2006745 SEASCAPE HOMES Forest Ave 2nd Floor 18" Depth 16" OC

SHOP DRAWING / SUBMITTAL REVIEW

Project # 2006745	Date: 3/9/2021	 360.384.9000
Sales: Daniel Turner	Name: SEASCAPE HOMES Forest Ave 1st Floor	
dturner@louwstruss.com	Sub.: 5202 Forest Ave SE Lot: #	
Design:	MERCER ISLAND WA 98040	
Roof area: 0 sq ft

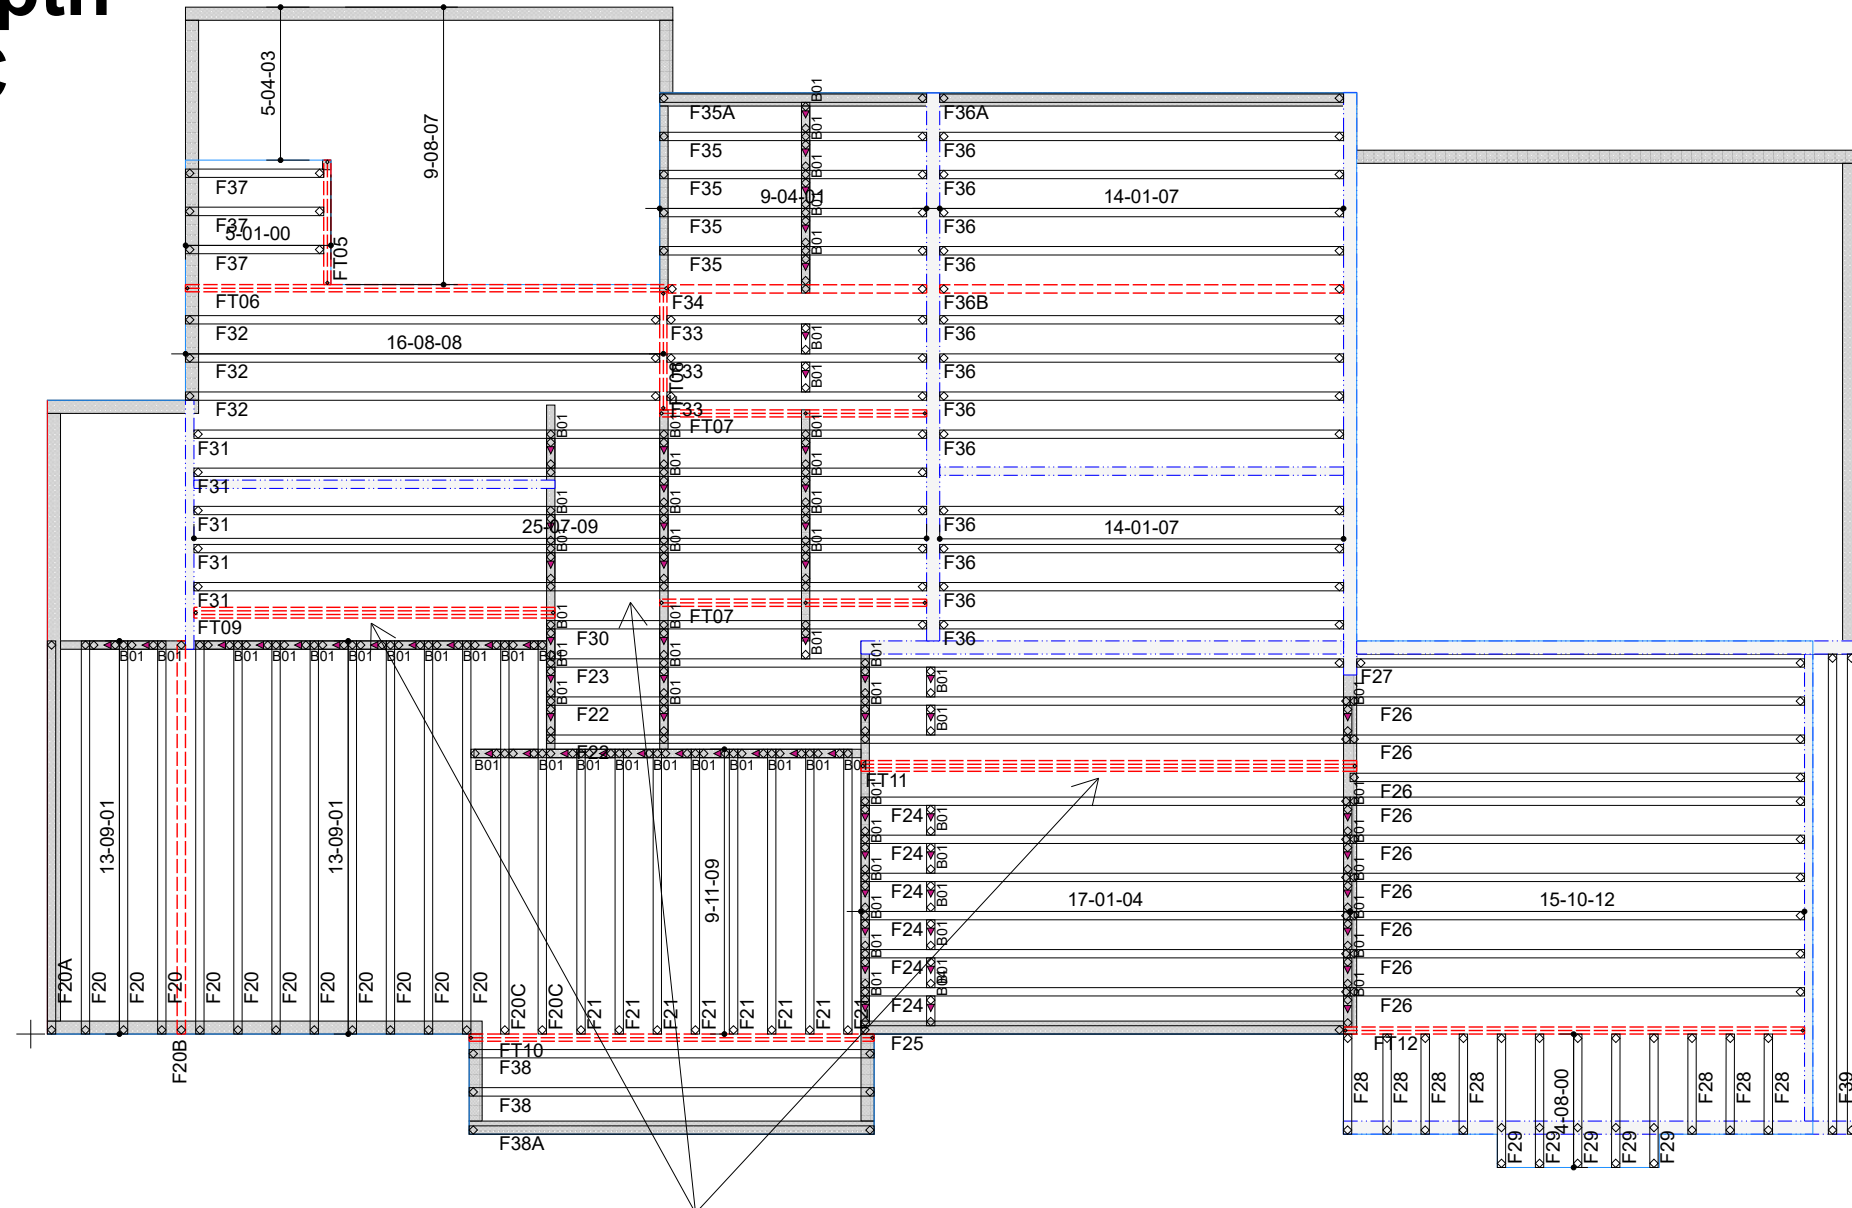
We're not seeing anything more specific about loads in these three places/girders. Specific load distributions can be added later.
